DOVER SCHOOL DISTRICT

JOINT BUILDING COMMITTEE – DOVER HIGH SCHOOL AND REGIONAL CTC MEETING NOTICE

JOINT BUILDING COMMITTEE
DOVER HIGH SCHOOL AND REGIONAL CTC
MINUTES

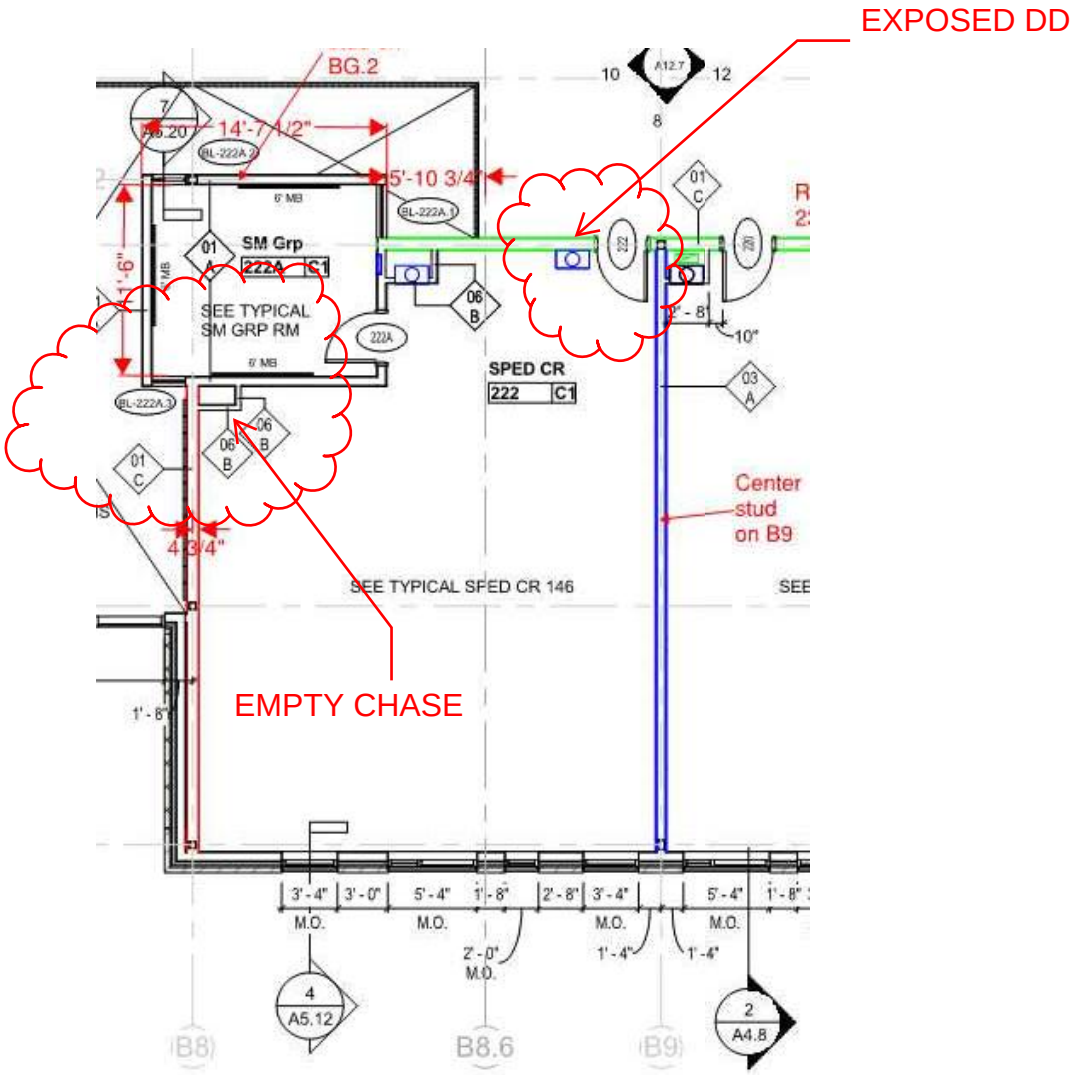
There is a displacement diffuser in the SPED CR-222 that is located next to door 222 that is exposed and not encased in framing. There is an empty chase in the NW corner of SPED CR 222. Please advise on if and where this DD is to be encased in framing. The framing for door 222 has been installed.

Delete the empty chase in the NW corner. Shift door 222 to the west and relocate the exposed DD in place of the door in the NE corner of the room. Encase the relocated DD in the corner similar to SPED CR 220.
